CONSOLIDATED THROUGHFARE PLAN

Lafayette Consolidated Government

Traffic & Transportation Department

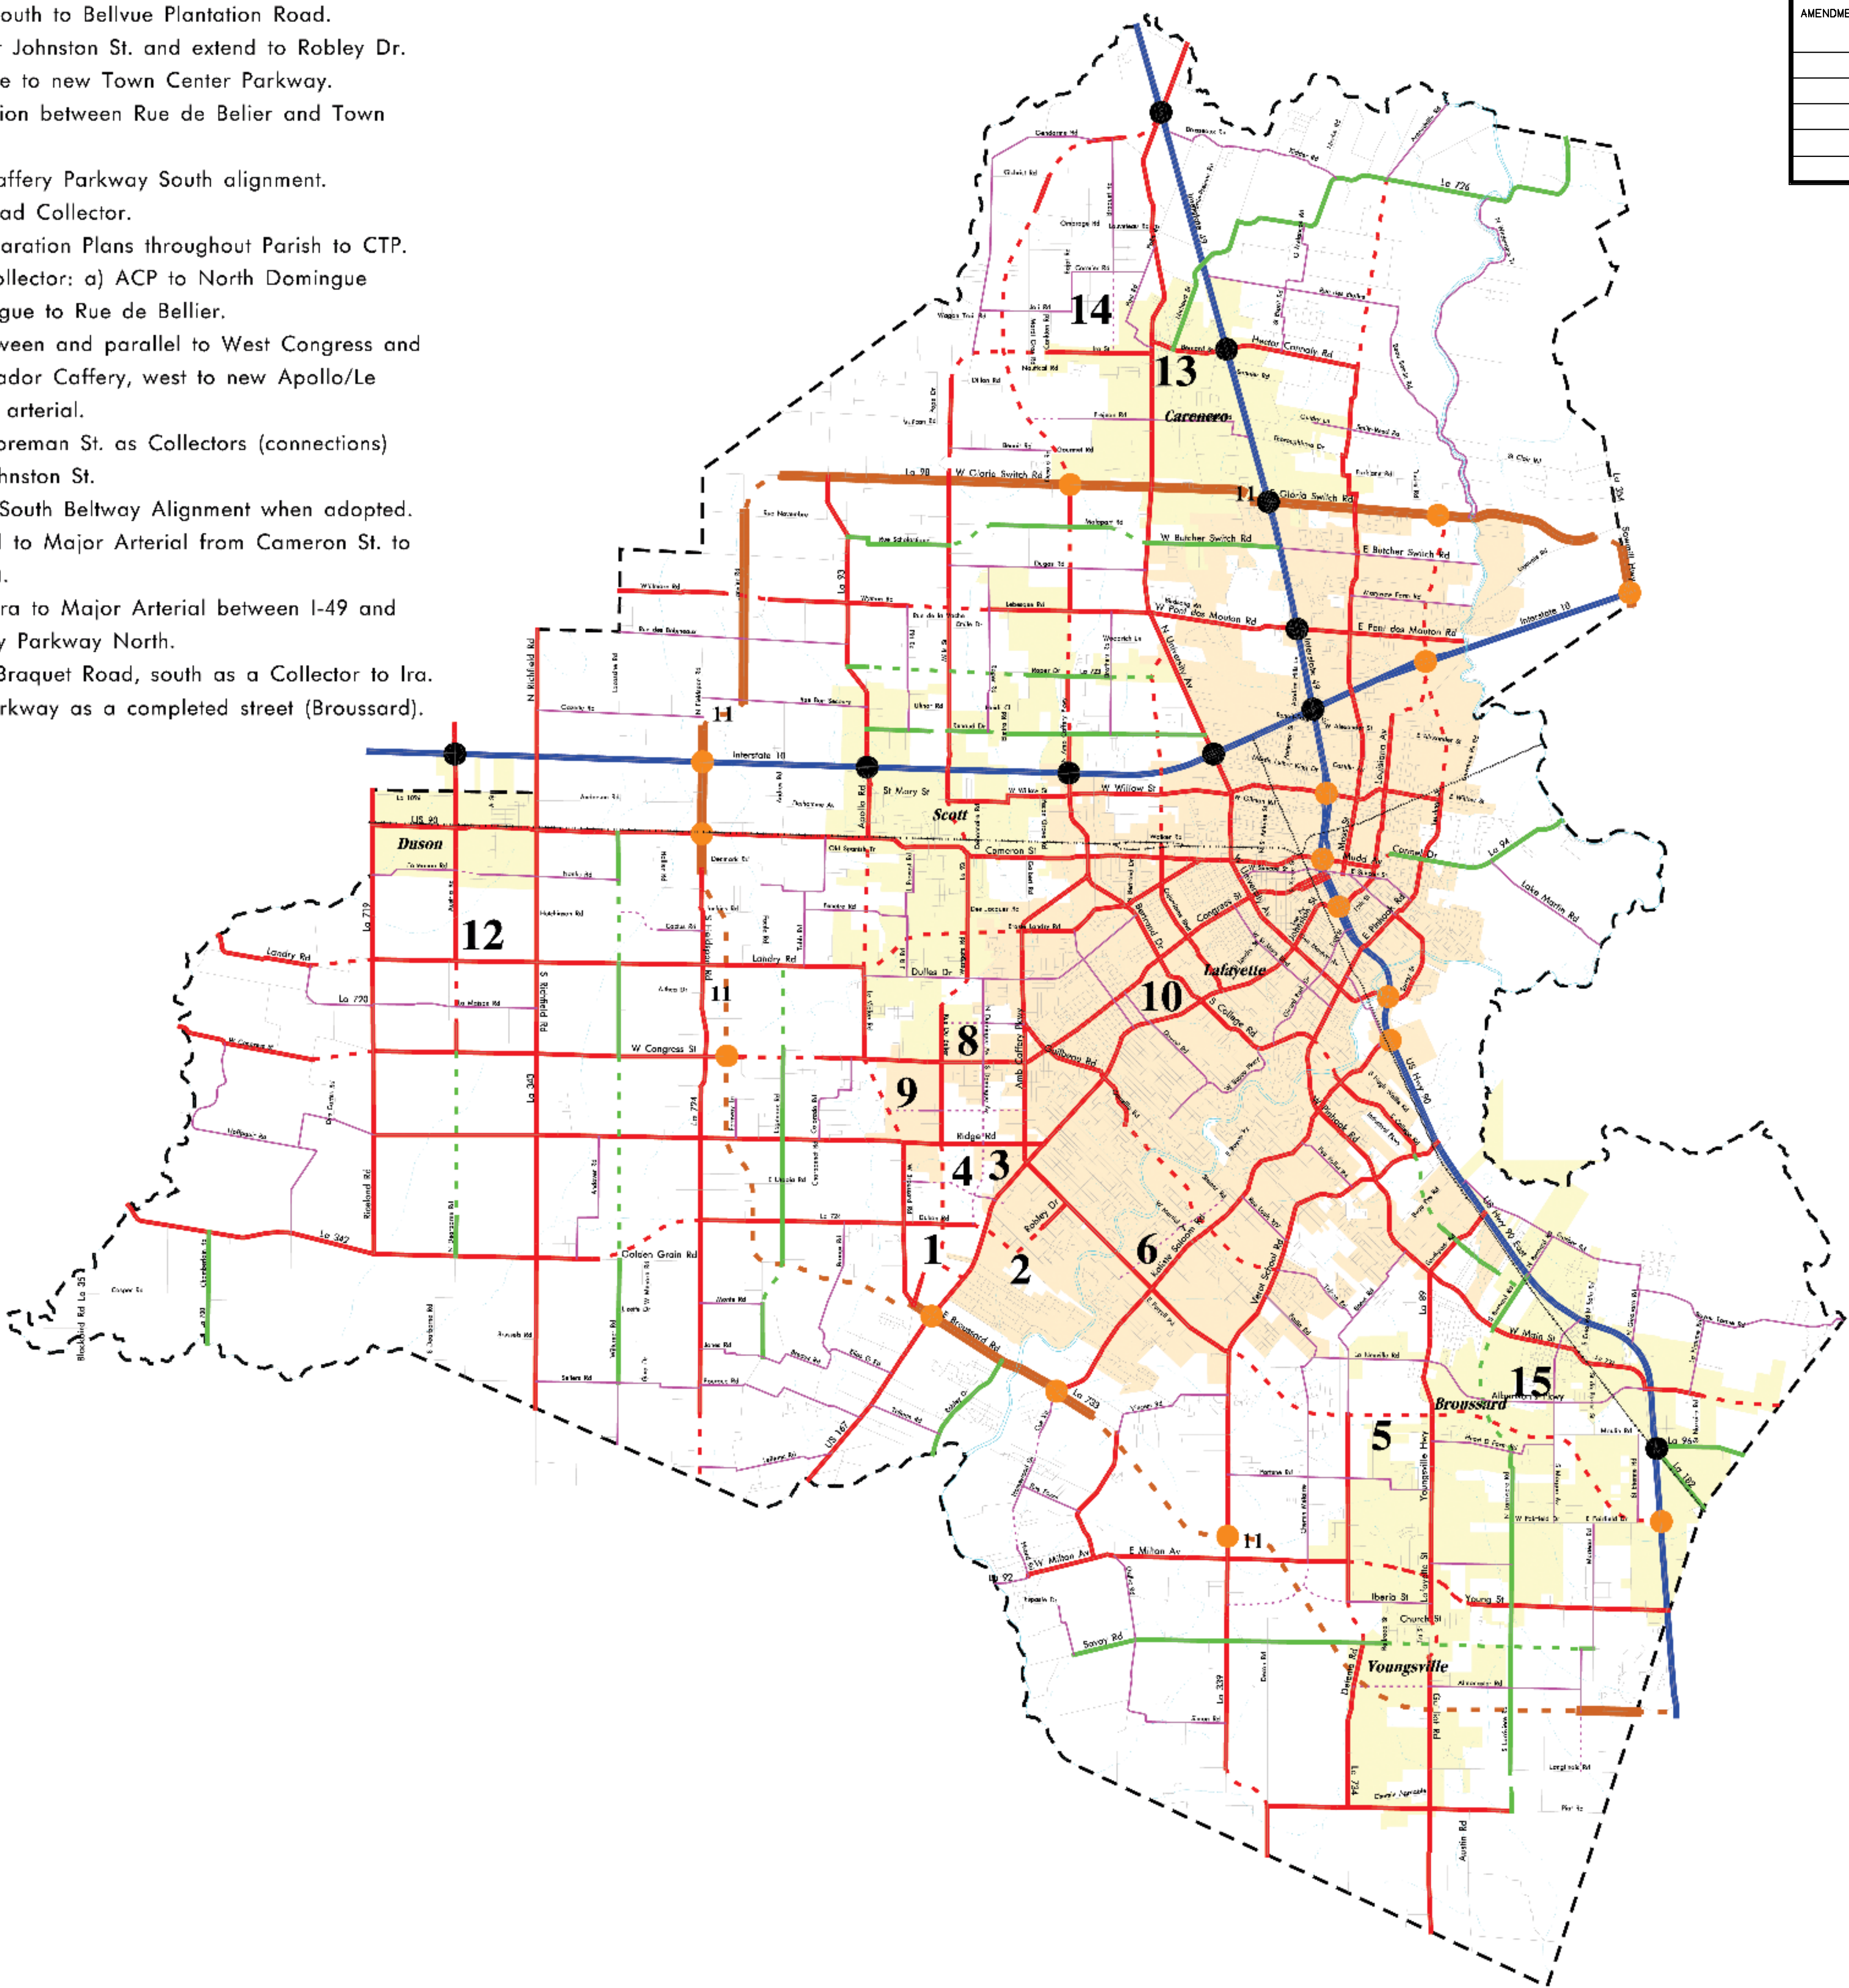
- 1) Extend Rue de Belier, south to Bellvue Plantation Road.
2) Realign Duhon Road at Johnston St. and extend to Robley Dr.
3) Realign South Domingue to new Town Center Parkway.

4) Eliminate curve connection between Rue de Belier and Town Center Parkway.
5) Correct Ambassador Caffery Parkway South alignment.
6) Add Kaliste Saloom Road Collector.

7) Consolidate Grade Separation Plans throughout Parish to CTP.
8) Add Guilbeau Road Collector: a) ACP to North Domingue and b) from North Domingue to Rue de Bellier.

9) Add new Collector between and parallel to West Congress and Ridge Road from Ambassador Caffery, west to new Apollo/Le Violin/W. Broussard Road arterial.

10) Reclassify Vital and Foreman St. as Collectors (connections) between Congress and Johnston St.
11) Identify correct North/South Beltway Alignment when adopted.

12) Upgrade Austria Road to Major Arterial from Cameron St. to West Congress St. (Duson).
13) Upgrade Bernard St./Ira to Major Arterial between I-49 and future Ambassador Caffery Parkway North.

14) Upgrade and extend Braquet Road, south as a Collector to Ira.
15) Identify Albertson's Parkway as a completed street (Broussard).
